GENERAL ELECTRIC

April 14, 1980

Attached are responses to the comments, questions and recommendations that have been made by consultants to the GETR Subcommittee of the Advisory Committee on Reactor Safeguards following the November 14, 1979 meeting. The first of these responses is to Merit P. White's questions dated February 18, 1980; the second, the recommendations made by Shailer S. Philbrick, December 14, 1979; and the third responds to comments or questions raised by Paul W. Pomeroy in his December 21, 1979 letter.

Responses to Comments by ACRS Consultant, Merit White

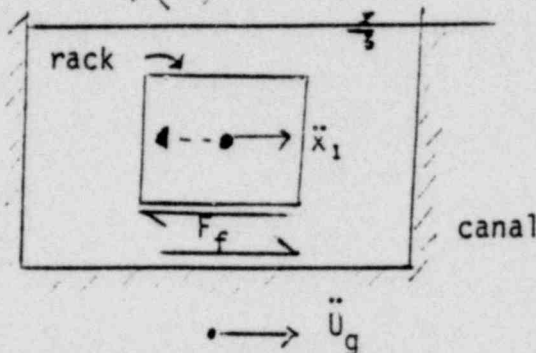
Updated Response to NRC request for additional information: Response to Question 11 regarding fuel storage racks: (Also GE Report DSAR 78-4, June 1978) What is the basis for the friction coefficient (0.349) used here? Reference to a memo quoting Dr. Rabinowicz is not enough. Can a copy of Dr. R's report be supplied? (Ref. GE VPF V5455, 1-3-78)

Response 12 of above: Questioned was the conservatism of the rack sliding calculations. The response stated that the assumed input was conservative and this is not an adequate response. For the following reasons I question the validity of the response calculation briefly discussed in DSAR 78-4 (ref. above):

1. The equations of motion given are incorrect since \ddot{u} must be identically zero part of the time (when there is no relative motion).
2. $m^1\ddot{u}$ is the driving mechanism. The very small value of m^1 (= M^1 in Table 2?) means that the input is weak. It is not obvious why m^1 is so small.
3. The extremely small predicted rack displacement - 0.16" - is hard to accept when one remembers that much weaker base motions have moved transformers and other objects by amounts of several inches.

1. The equations of motion given in DSAR 78-4 are applicable only when the rack slides. $m\ddot{u}$ is identically equal to zero when the rack does not slide.

2. (a) m^1 is the same as M^1 in Table 2.
 (b) The equation of motion during the sliding can be derived as follows:

$$\left(\begin{bmatrix} M_1 \\ M_2 \end{bmatrix} + \begin{bmatrix} m_1 - m_{12} \\ -m_{12} \quad m_2 \end{bmatrix} \right) \begin{Bmatrix} \ddot{x}_1 \\ \ddot{U}_g \end{Bmatrix} + \begin{Bmatrix} F_f \\ -F_f \end{Bmatrix} = \begin{Bmatrix} 0 \\ 0 \end{Bmatrix} \quad (1)$$

M_1, M_2 are structural masses of the storage rack and the canal, respectively. m_1, m_2 and m_{12} are hydrodynamic masses. X_1 and U_g are respectively the accelerations of the rack and the canal. F_f is the friction force. Let $\ddot{x}_1 = \ddot{U} + \ddot{U}_g$, where \ddot{U} is the relative acceleration between the rack and the canal. Equation (1) can be rewritten as follows:
